This is a  
**CONTROLLED DOCUMENT (5)**  
FUGRO FLATS PLANT  
ENVIRONMENTAL MANAGEMENT DEPARTMENT  
This is a RED Stamp  
COPY # 128

Amendment #1  
to the  
Final Site Specific Health and Safety Plan  
for the  
Source Removal at the Mound Site IHSS 113  
9-23-97

Figure 2.1  
Project Organization

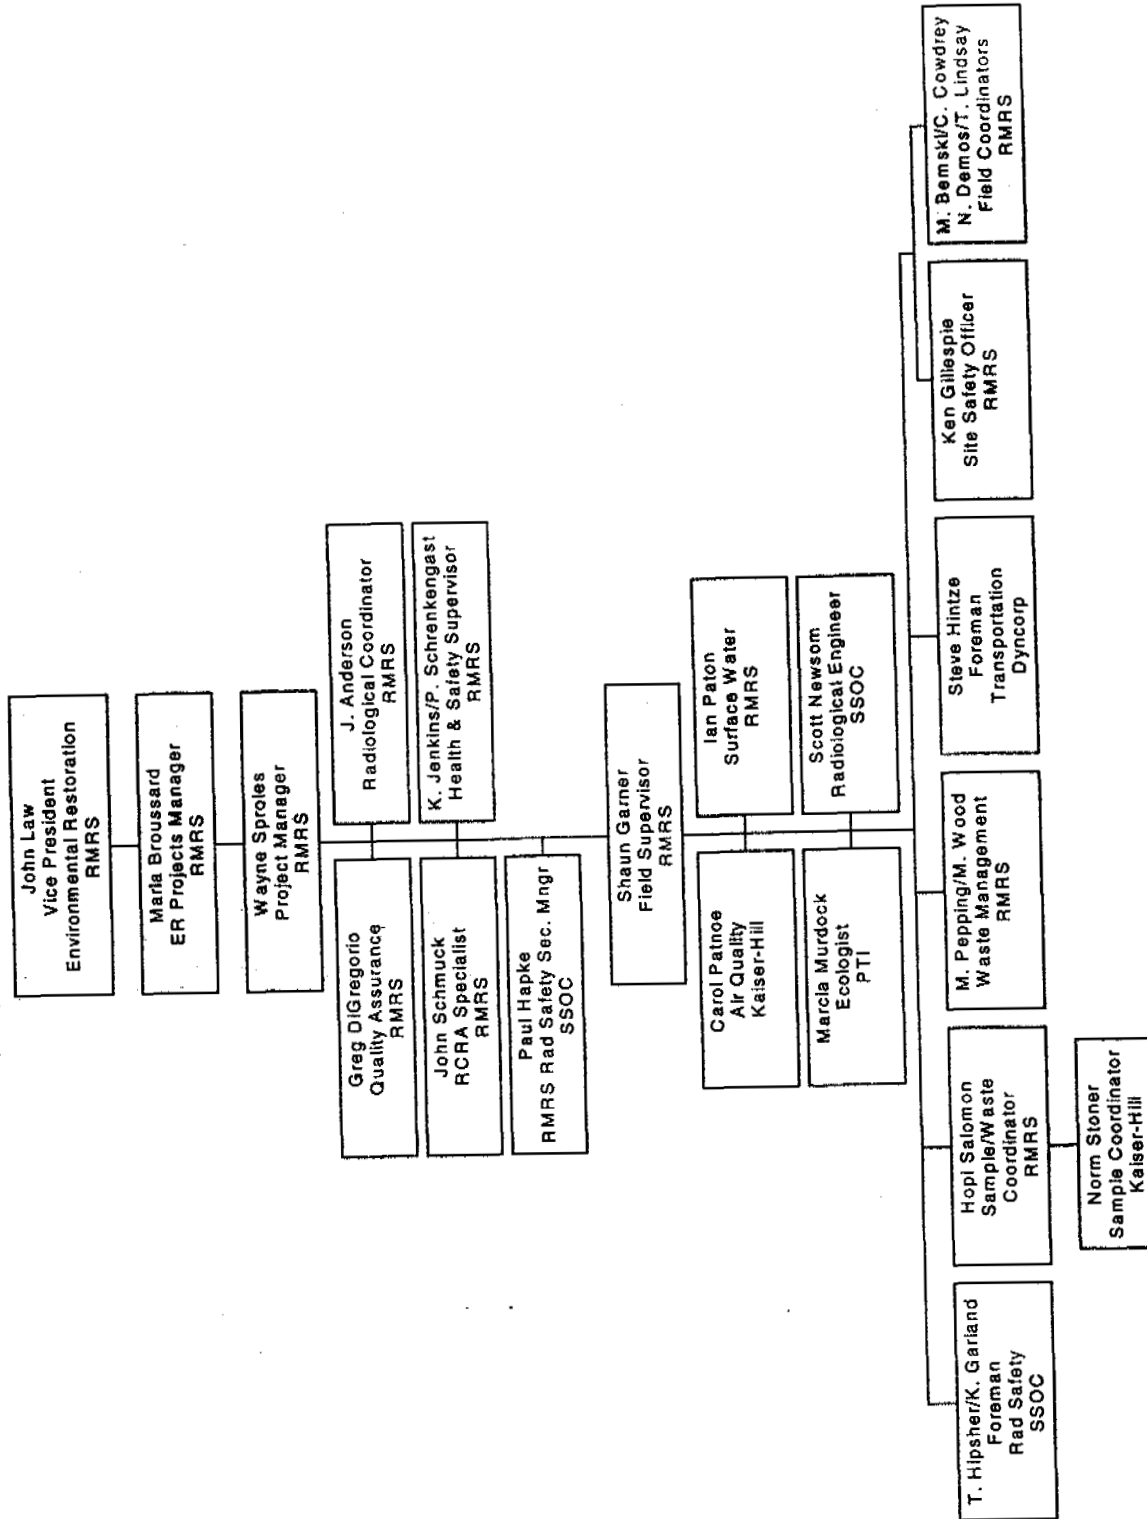
Project personnel responsibilities remain the same. Figure 2.1 has been revised and is attached.
